BULLETIN NO: 278

SUBJECT: Addition of transmit interlock capability to the VC 401B Series III Communications Transceiver.

IB #278

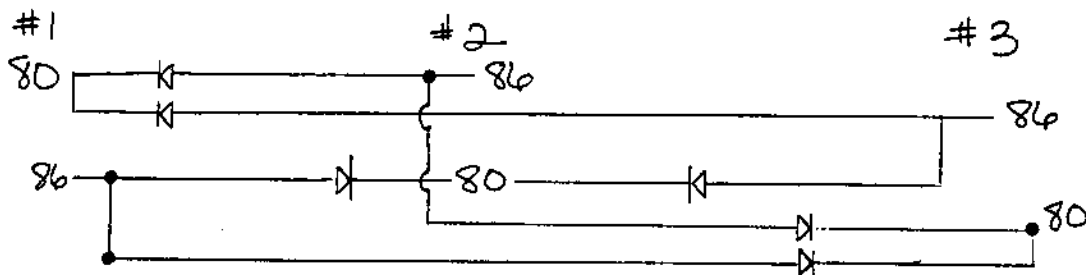
It has come to the attention of BENDIX/KING that some operators of Series III VC 401B Communications Transceivers have experienced crosstalk problems. It usually occurs when there is insufficient antenna isolation to prevent the 20 watt transmitter of one VC 401B from overwhelming the receiver of the second VC 401B.

To correct this problem, unit Mod 5 to the VC 401B has been created. This modification adds a transmit interlock function that reduces the gain of the affected receiver so the copilot won't hear the pilot's transmissions on a different frequency. In order for this interlock to function two (2) wires must be added to the installation between the MIC push-to-talk line (connector P1001, Pin 80) of one transceiver and the new transmit interlock function pin (P1001, Pin 86) of the other.

| <u>VC 401B #1</u> | <u>VC 401B #2</u> |
| P1001 | P1001 |
| P-T-T 80----- | 86 TX INTLK |
| TX INTLK 86----- | 80 P-T-T |

In order for this modification to be effective, both unit Mod 5 and this installation bulletin must be complied with.
